Serial No. 09/731617

Amendment dated February 5, 2004

Response to Office Action dated November 5, 2003

REMARKS/ARGUMENTS

Applicant Kahle and Moore Docket: AT9-99-445 Sheet 3 of 4 Contact J. Lally 512/428-9870

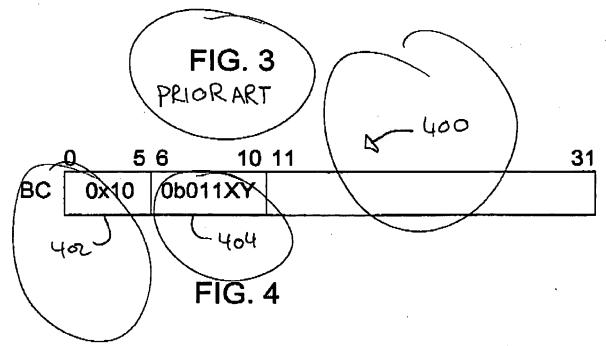
The Examiner also requested that a PRIOR ART designation be included on FIGs 1-3. Applicant has amended FIG 3 to include the PRIOR ART designation, but Applicant would respectfully submit that FIGs 1 and 2 do not depict prior art. FIG 5 illustrates selected details of a branch prediction unit 206 according to the present invention. FIG 2 illustrates selected elements of a microprocessor 101 that includes branch prediction unit 206. FIG 1 illustrates selected elements of a data processing system 100 that includes microprocessor 101. Thus, FIG 1 and FIG 2, both include the branch prediction unit that is illustrated in FIG 5 and therefore illustrate more than that which is old. Consistent with the requirement under 37 CFR 1.84(p)(4) requiring that reference numerals be used consistently throughout the different drawings, Applicant would respectfully submit that FIG 1 and FIG 2 are not prior art because they both include the novel branch prediction unit 206. Accordingly, Applicant requests the Examiner to reconsider and withdraw the objections to FIG 1 and FIG 2 and to withdraw the objections to FIG 3 and FIG 4 based on the proposed drawing amendments.

Applicant: Kahle and Moore Docket: AT9-99-445 Sheet 2 of 4 Contact J. Lally 512/428-9870

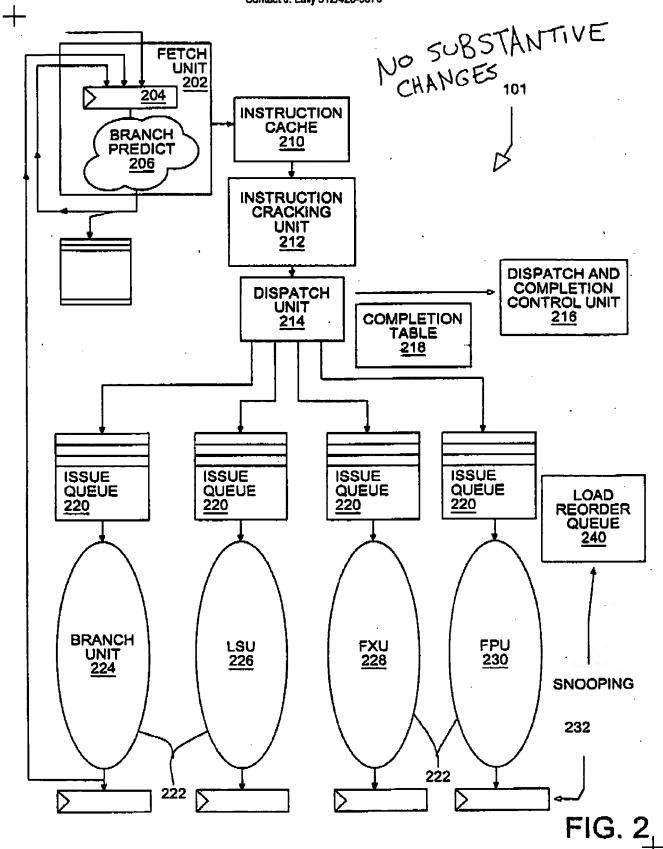
Applicant has submitted a proposed set of four drawings sheets to replace the originally submitted drawing sheets. FIG 4 has been amended to include reference numerals 400, 402 and 404, which were included in the specification but inadvertently omitted from the originally submitted drawings. Applicant thanks the Examiner for catching this error.
